STARTING — PNEUMATIC STARTER — INTRODUCTION OF A REVISED PNEUMATIC STARTER
WITH AN IMPROVED MAGNETIC SEAL AND NEW GEAR CAGE STEEL SLEEVES

Turbojet Engine Service Bulletin No. V2500-ENG-80-0024 Revision No. 2 dated December 18, 2013.

STARTING - PNEUMATIC STARTER - IMPROVED MAGNETIC SEAL

STARTING - PNEUMATIC STARTER - IMPROVED GEAR CAGE AND INSERTS

FAMILY TREE — V2500-A1, A5 AND D5 PNEUMATIC STARTER
CHART A, SHEET 1

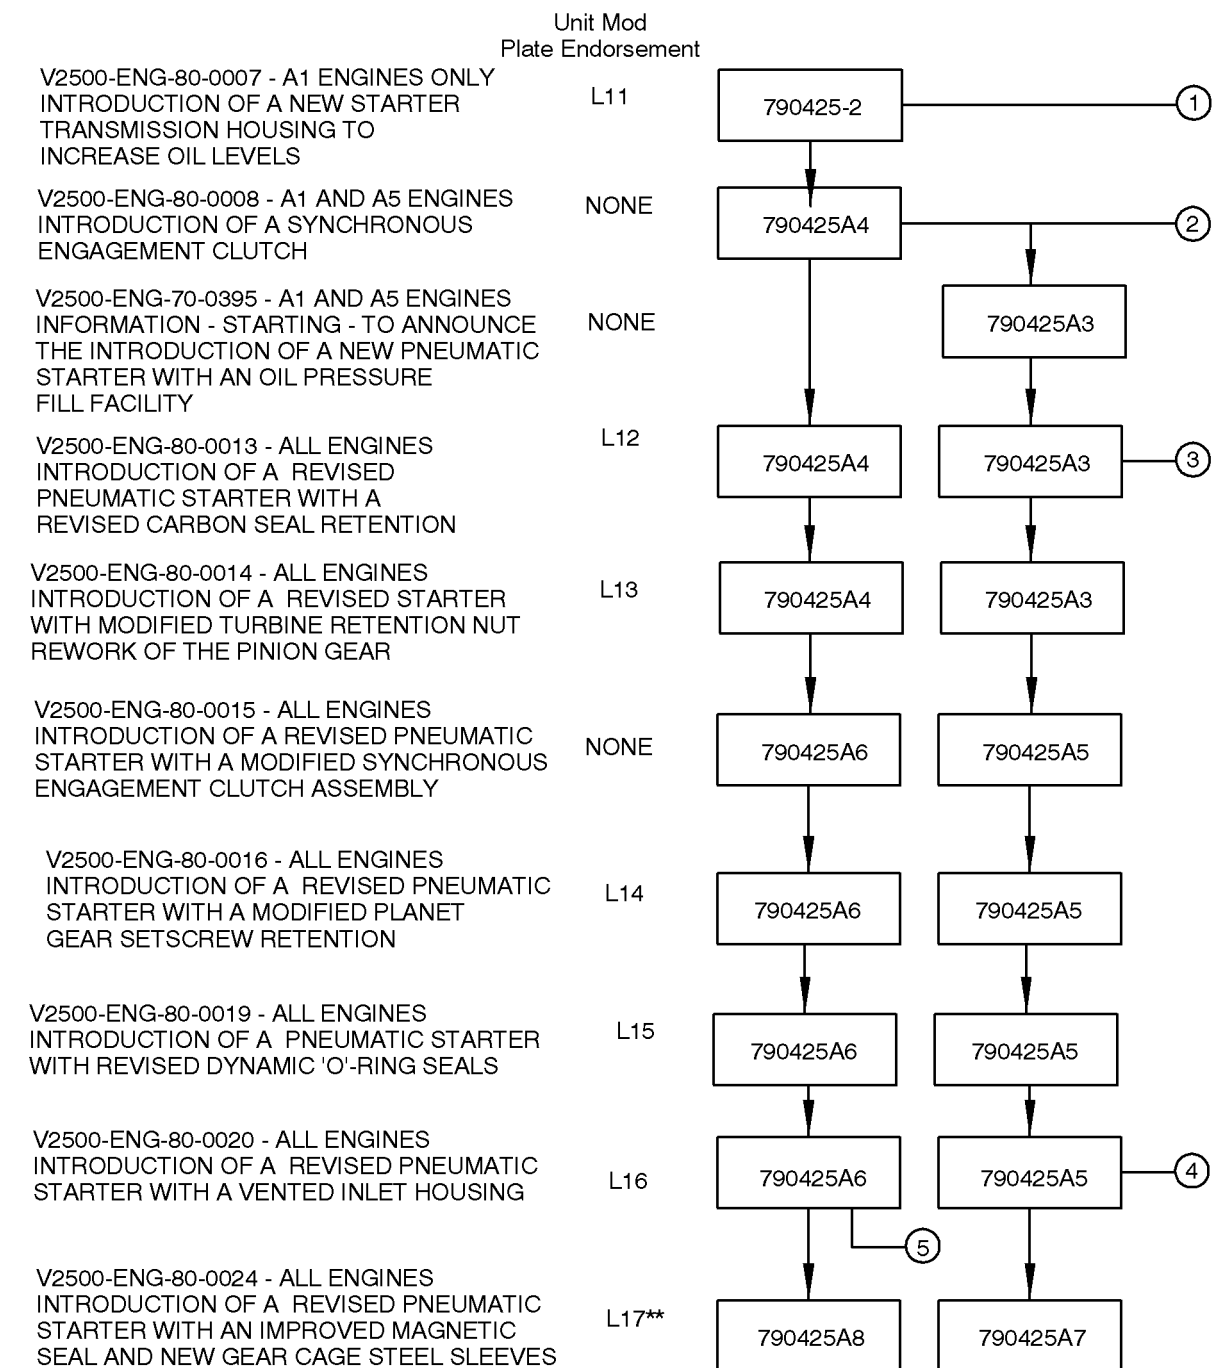
** THE L NUMBER ONLY ADVANCES TO L17 WHEN SPP SB 80-2520 IS ACCOMPLISHED
PART NUMBER ADVANCES WHEN SPP SB 80-2521 IS ACCOMPLISHED

Figure 1
Assembly of the Magnetic Seal

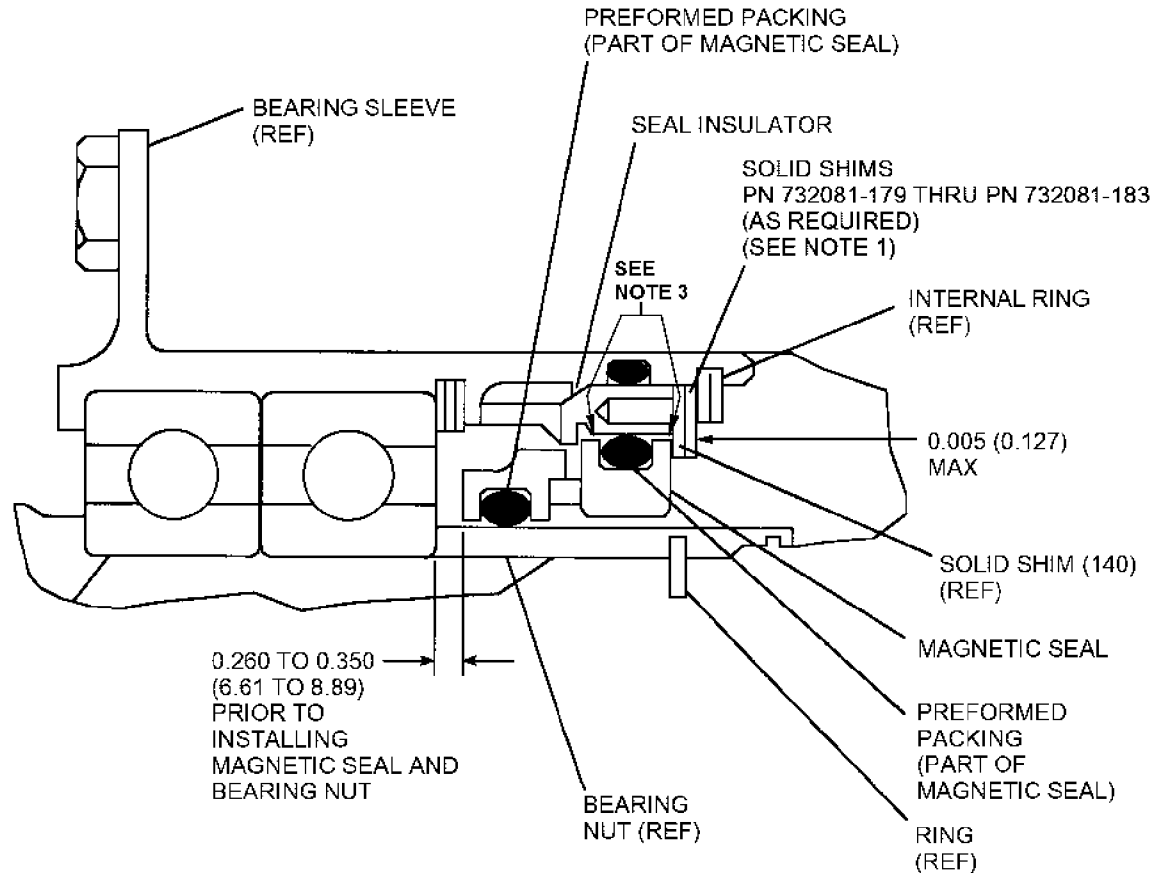
- (a) Temporarily install the seal insulator (150), solid shim (140) and the internal retainer ring (130) in the bearing sleeve (340) as shown in Figure 1. Use a feeler gauge to measure the gap between the solid shim (140, IPL Figure 1) and the internal retainer ring (130). Determine the quantity of solid shims, PN 732081-179 thru PN 732081-183, required to reduce the gap to 0.005 inch (0.127 millimeter) maximum. Remove the internal retainer ring (130).
- (b) Temporarily install a sufficient quantity of solid shims, PN 732081-179 thru PN 732081-183, so that a 0.005 inch (0.127 millimeter) feeler gauge cannot be inserted after the internal retainer ring (130) is installed.
- (c) Remove the internal retainer ring (130), the temporarily installed solid shims, PN 732081-179 thru PN 732081-183, and the seal insulator (150).

- (h) Install the magnetic seal (160) on the bearing nut (230). Put the magnetic seal 0.260 to 0.350 inch (6.61 to 8.89 millimeters) from the end of the bearing nut (230) as shown in Figure 1.

- (l) Install the internal retainer ring (130) in the bearing sleeve (340). The internal retainer ring (130) must be fully engaged in the ring groove of the bearing sleeve (340) as shown in Figure 1.

1. TEMPORARILY INSTALL SOLID SHIMS AND THE INTERNAL RETAINER RING AS SHOWN. INSTALL A SUFFICIENT QUANTITY OF SOLID SHIMS TO GET A 0.005 (0.127) MAXIMUM CLEARANCE BETWEEN THE INTERNAL RETAINER RING AND THE SOLID SHIMS.
2. DIMENSIONS IN INCHES (MILLIMETERS).
3. COAT ID OF INSULATOR AT INCLUDED AREA WITH A THIN LAYER OF ULTRACHEM ASSEMBLY FLUID NO. 1.
4. ITEM NUMBERS REFER TO IPL FIGURE 1.
